Access Compliance Report

Public Rights-of-Way

(Curb Ramps)

Intersection ID: 15070	Main Street: IDEAL_WY	Cross Street: REMOUNT_RD	Location: SW
ADA ID: 347FEBB556AC	Ramp Type: Perp	Initial Pass/Fail: Fail	Overall Compliance: No
Severity Score: 22.5			
Codes/Mitigation Info/Possible Solution		Field Measurements/Component Compliance

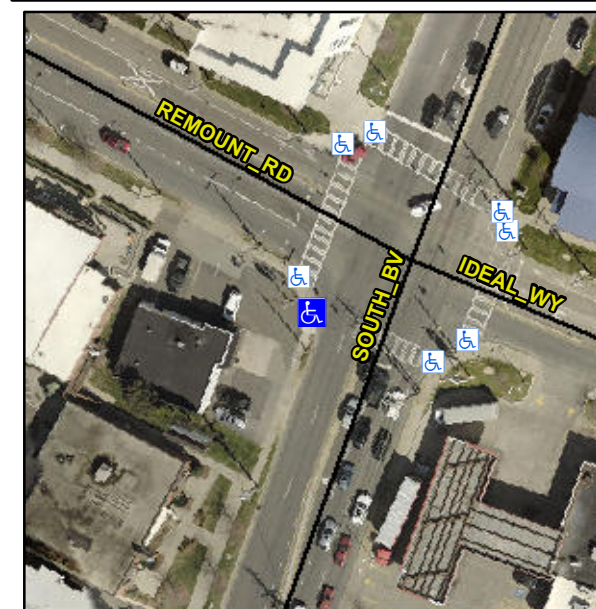
Not Found, R304.5.1, R304.2.2, R304.5.3

Compliance	Description	Data	Compliance	Description	Data
N/A	Ramp Length (in)	72.0	No	Ramp Slope (%)	9.6
No	Ramp Width (in)	47.5	No	Ramp XSlope (%)	3.5
N/A	Flare Type LT	N/A	N/A	Flare Type RT	N/A
N/A	Flare Slope LT (%)	N/A	N/A	Flare Slope RT (%)	N/A
N/A	Flare Traversable LT?	N/A	N/A	Flare Traversable RT?	N/A
N/A	Landing Length (in)	N/A	N/A	DWS Provided?	N/A
N/A	Landing Width (in)	N/A	N/A	DWS Contrast?	N/A
N/A	Landing Slope (%)	N/A	N/A	DWS Length (in)	N/A
N/A	Landing X Slope (%)	N/A	N/A	DWS Full Width?	N/A
N/A	Landing Curb? (Y/N)	N/A	N/A	DWS Offset (in)	N/A
N/A	Shared Landing?	N/A			
N/A	Gutter Ponding?	N/A	N/A	Gutter Slope (%)	N/A
N/A	Gutter Lip Ht (in)	N/A	N/A	Gutter X Slope (%)	N/A
N/A	Painted X Walk1?	Yes	N/A	Painted X Walk2?	N/A
	X Walk 1 Direction	To SE		X Walk 2 Direction	N/A
N/A	X Walk 1 Width (in)	98.0	N/A	X Walk 2 Width (in)	N/A
	X Walk 1 Slope (%)	1.6		X Walk 2 Slope (%)	N/A
	X Walk 1 X Slope (%)	3.0		X Walk 2 X Slope (%)	N/A

Remove & Replace Entire Ramp.
